Bartons Road, Havant

24-097-RPT 008 Rev A

Response Note to HCC Lead Local Flood Authority

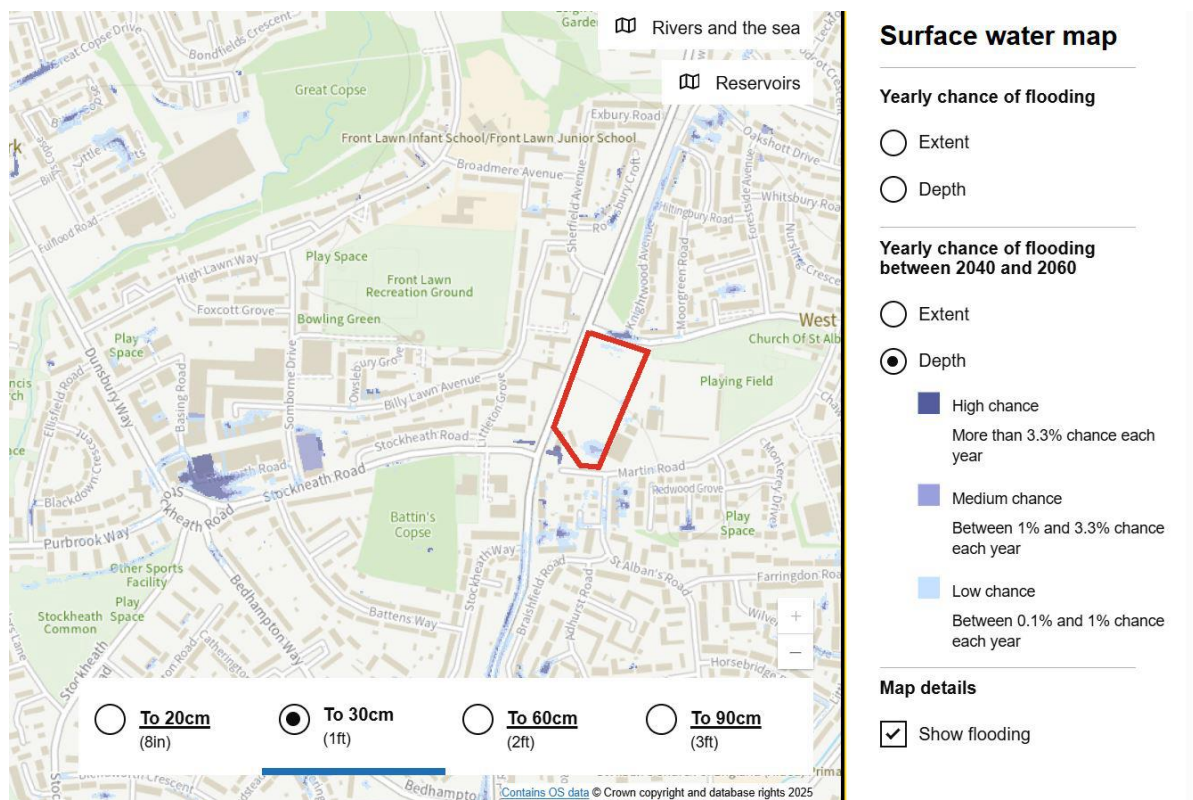
- 3.1.1 The FRA identifies a surface water flood flow path running through the site, along the western boundary, together with some separate localised areas of surface water flooding within the site. The LLFA expressed concern about the accuracy of the flood mapping used to determine this and suggest that flood modelling may be required to properly assess the impact of this flood risk on the development. The EA's "Flood Map for Planning" website was used to determine the route and extent of this flow path and the other surface water flood risk areas.

- 3.1.2 This, as the website suggests, is deemed sufficient to assess flood risk at planning stages of developments and therefore it is considered that the FRA adequately assesses the flood risk posed by the existing surface water flow path. This path will be maintained free from any built development and there will be no drainage attenuation features located within this flow path.

- 3.1.3 The LLFA also suggest that there may be a loss of flood storage on the site due to construction of the development. As noted above the surface water flow path which currently crosses the site will continue to do so unhindered and at the same ground levels so the construction of the development will not impact this flow route.

- 3.1.4 The above flood mapping also identifies some areas at potential risk from surface water flooding during extreme rainfall events. These are remote from the flow path and are the result of localised shallow surface water ponding within low lying areas on the site. Drawing 24-097 011 in **Appendix C** interpolated from the EA's flood map drawings shows the location of the surface water flow path in relation to the areas of on site ponding.

- 3.1.5 Figure 5-4 in the original FRA, see below, taken from the EA's published flood mapping, shows that the yearly chance of flooding from this localised ponding up-to 2060 is low, with only a small area in the south east corner of the site at risk of flooding to a depth of 30cm.
